Questions and Answers for N00173-02-R-AT02:

ELECTRON BEAM THIN FILM EVAPORATION SYSTEM WITH IN-SITU
ANGLED EVAPORATION CONTROL

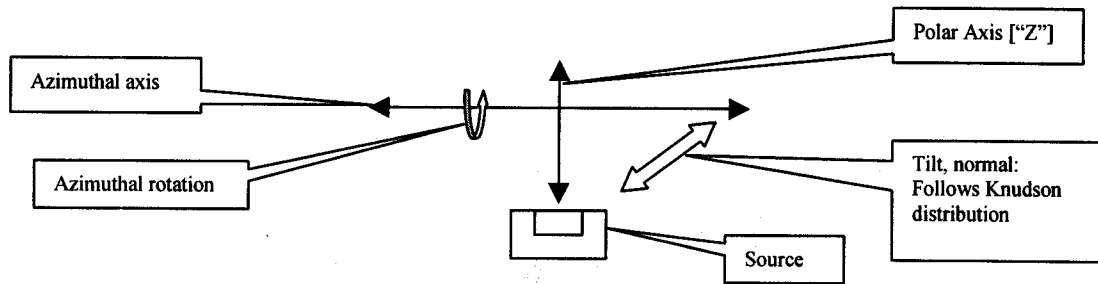
24. I would like to clarify the "Primary Holder" requirement for "tilt".
i) Are you looking for Tilt of the Azimuthal axis about it's axis [Azimuthal rotation], or Tilt of the Azimuthal axis with respect to the Polar axis [Tilt, normal]. Please see Below:

Answer: Capability to tilt the substrate holder to an indexed specific angle respect to Polar Axis (Z axis) along with the capability to rotate the substrate holder respect to the axis that is orthogonal to the substrate holder at specific tilt angle.
